## **Response to the Referee comments**

**RE: hess-2015-167, Temperature and rainfall estimates for past 18,000 years in Owens Valley, California with a coupled catchment-lake model**

Figure 3. Model Inputs, Components and Processes of the Coupled Catchment-Lake Model

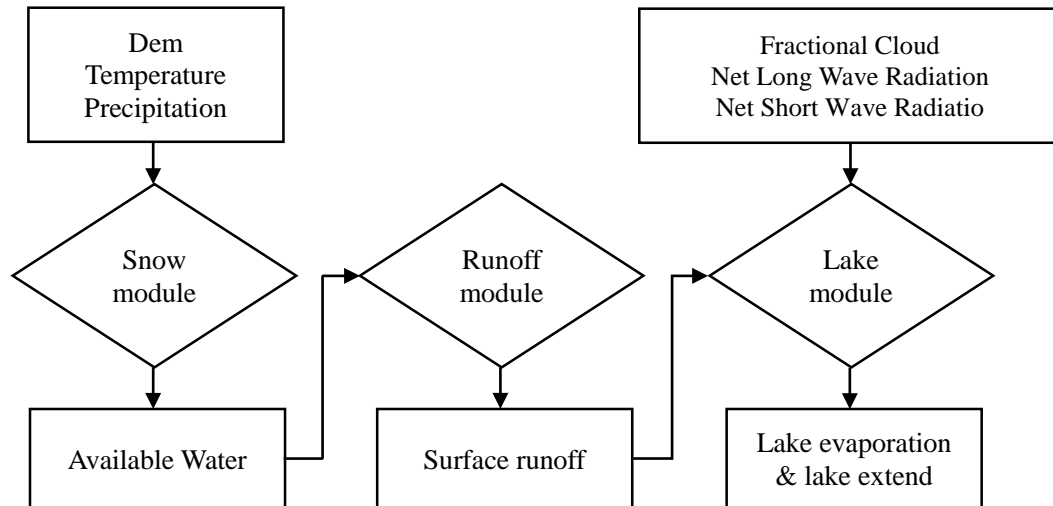
**Comment-3:** Section 3 - describing the modeling approach - needs to be improved. A reader cannot look at this section and understand how this modeling was done. The model needs to be described systematically including some of the mathematics. If much of this work is represented by older work, then at least provide some of this material as "Supporting Information". It is important to emphasize what is new in this study and what has been done previously. I still think the test of sufficiency is the ability to reproduce the model based on descriptions in the paper. At this stage, the descriptions come up short.

**Response-3:** Following the reviewer's comments, we will expand this section to describe the modeling approach in detail by providing a conceptual framework of the model and adding the introduction of each module including the snow module, the runoff module, and the lake module in this section. An initial revision is presented as below and will be edited and added to the final revised manuscript:

"..... In this study, the lake module in the OSHM was modified with the addition of Hostetler's lake model to replace the empirical equation and used to simulate evaporation over the lake surface. A flow chart including the model components, inputs and relationships of the coupled catchment-lake model is showed in Figure 3.

Figure 1. Location map of Owens River system (Modified from Smith and Bischoff, 1997).

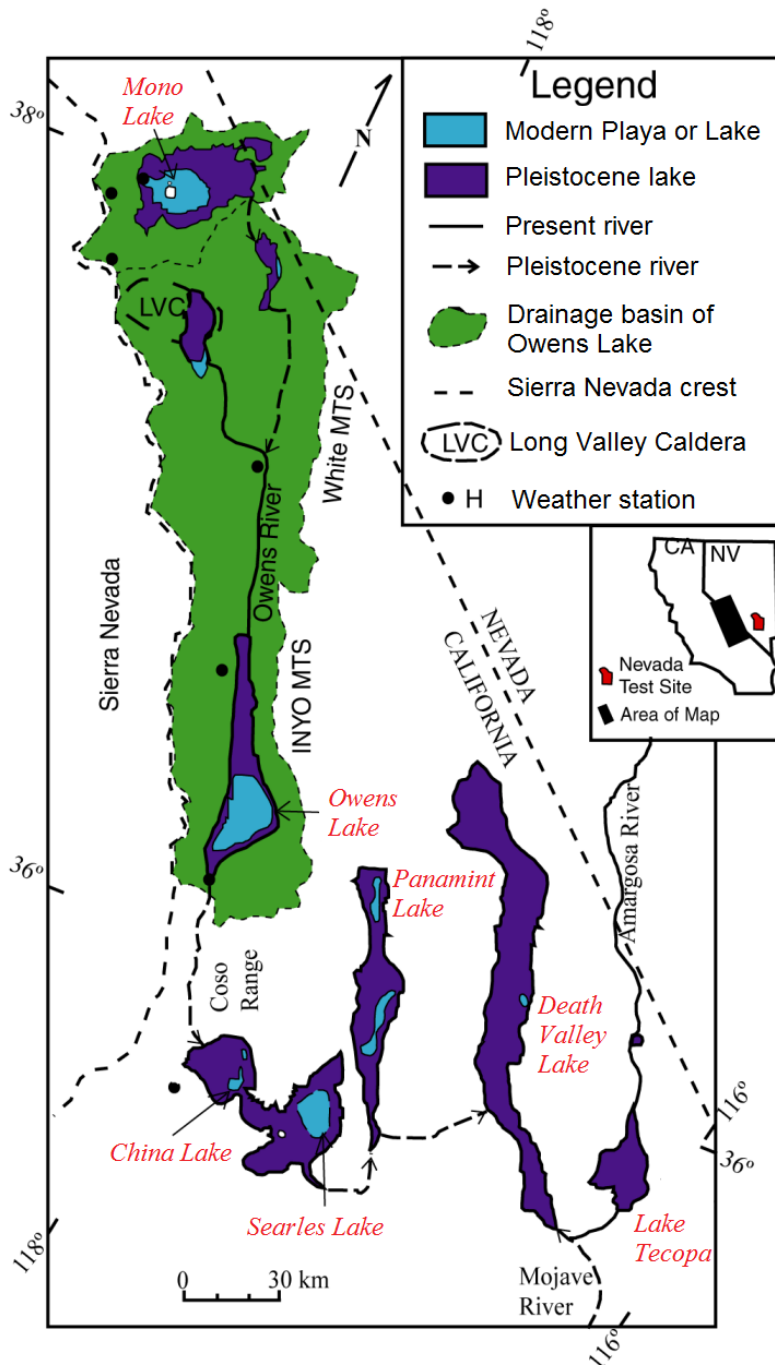
The figures need improvements as well. Figure 1 has overly small fonts. Figure 2 is a cluttered mess with some lines undefined and missing units (e.g., per mil). Figure 7 has 6 small maps which are difficult to see and compare. I would suggest a 2-D schematic map providing the sequence of lakes in proper elevation context (like a computer program flow chart) with a 2-D basin shape with elevations.

We also revised the figures as suggested. The fonts in Figure 1 were enlarged. Figure 2 was revised by showing the legend and units. For Figure 7, we didn't understand the suggestions by the reviewer very well. We want to illustrate the changes of simulated lake extents during different periods. As a result, we simplified the factors in the map which only include lake extents (Deep Blue), stream network (Light blue), and hillshade (Gray). For Figure 8, the temperature and precipitation estimated from pollen is a time series while the simulated data is one year average temperature and precipitation at specific time snapshots (modern time, 3ka B.P., and etc.). We cannot direct compare them rather than looking at the trends. The temperature

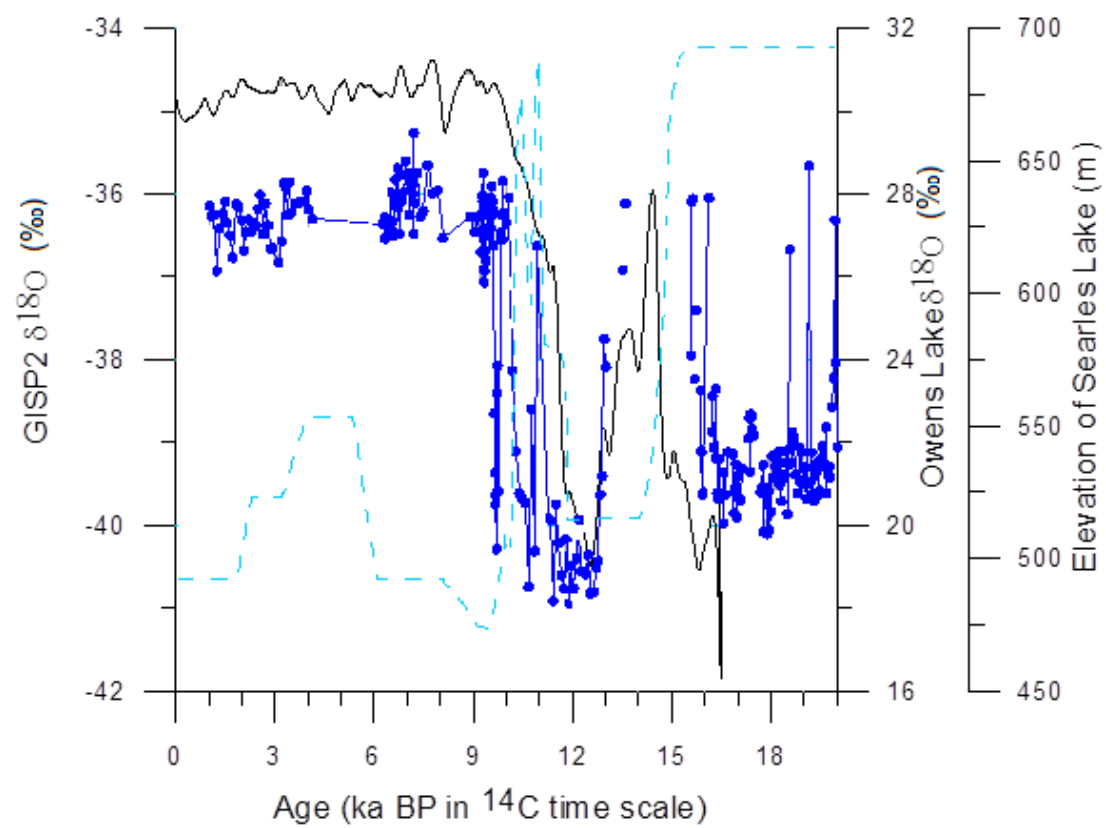
1. Page 6512 Line 24: "Monon" should be "Mono".
2. Missing units for the Y Axis in Figure 2.

**Response-Typing Errors:** We thank the reviewer for pointing out the typing errors. We have corrected them in the final revised manuscript.

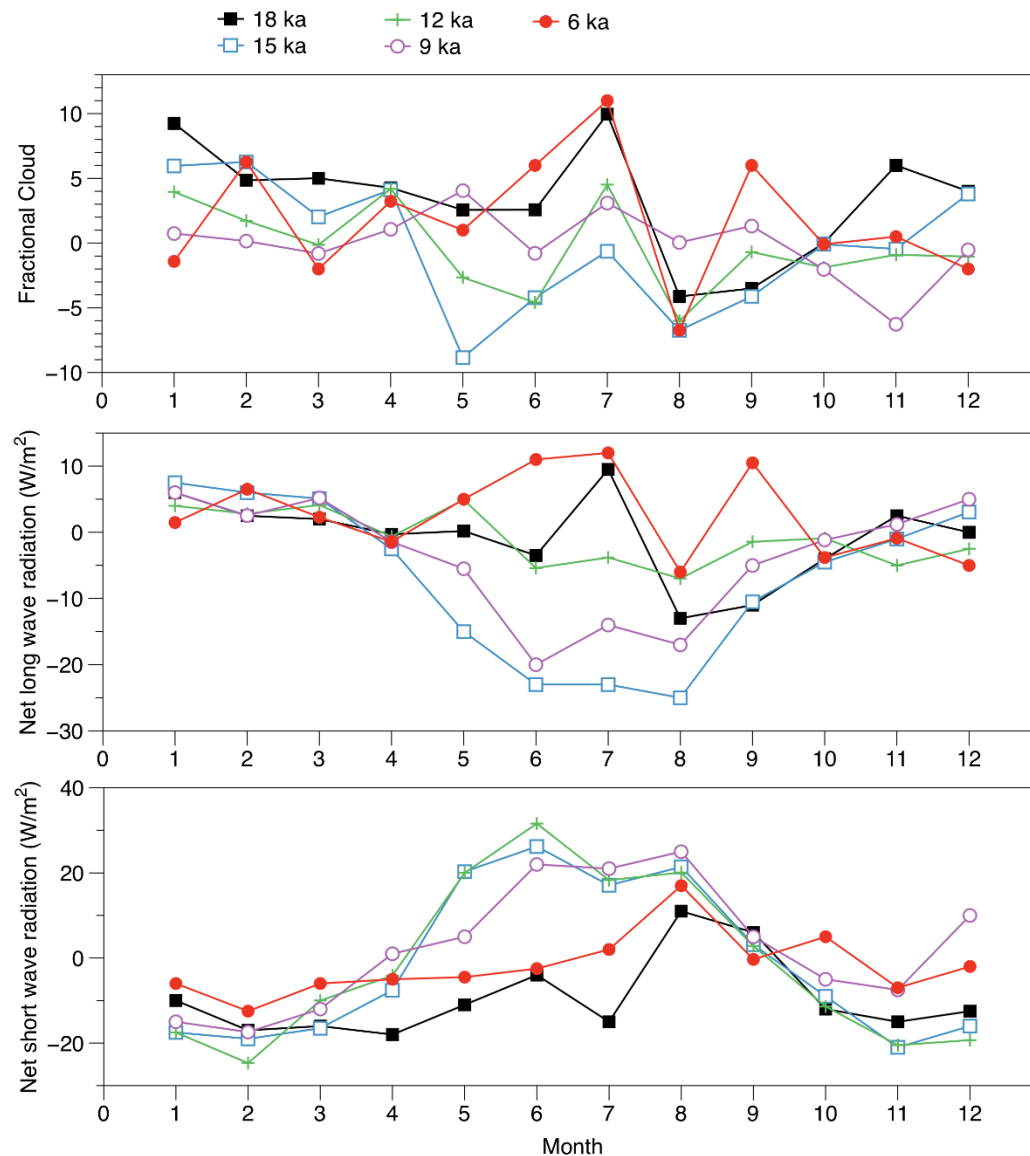
7. Figure 5, page 6536: The three figures are not readable. Please use different line patterns, colors, and larger labels for better illustration.

**Response-7:** Figure 5 was revised as suggested below:
